**ZONING AND PLATTING COMMISSION
SITE PLAN VARIANCE REQUEST REVIEW SHEET**

CASE: SP-2013-0441D

PROJECT NAME: 3961 Westlake Drive

**PEDESTRIAN INCLINE
ELEVATOR FOR 3961
WESTLAKE DRIVE
SP-2013-0441DS**

Existing shoreline access

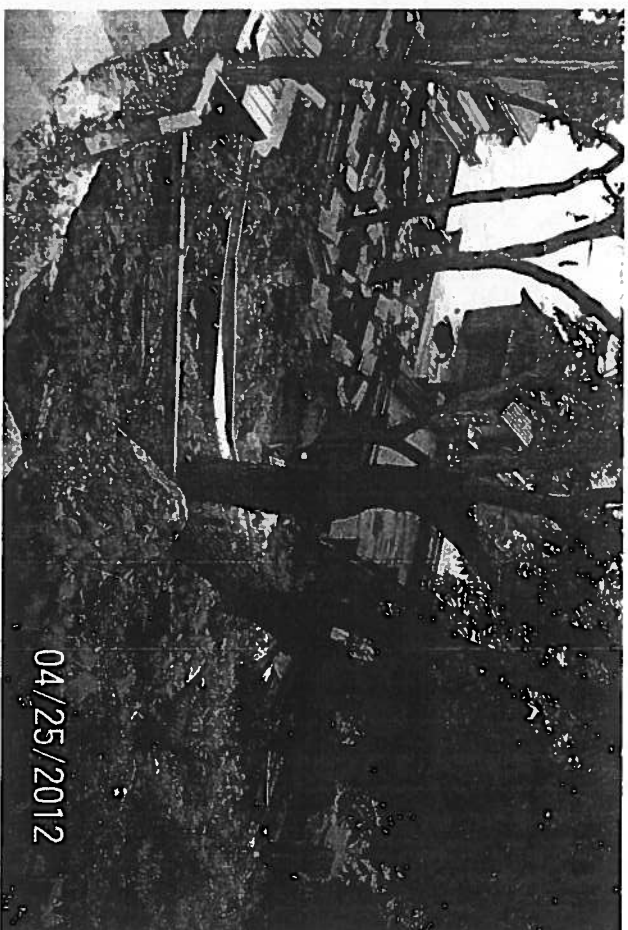
No. Shoreline access in the form of stairs has existed on this property for decades with shoreline access in the form of stairs. New stone steps were constructed for the boat dock that was recently permitted in 2011.

No. The applicant could choose to remove the existing steps used for shoreline access and restore and revegetate the disturbed area within the Critical Water Quality Zone. This restoration would eliminate the need for a CWQZ variance entirely.

No. Disturbance within the Critical Water Quality Zone is limited in order to attempt to preserve the integrity of the riparian corridor. The existing shoreline access is already quite extensive in the setback and staff finds that additional disturbance would create further disturbance.
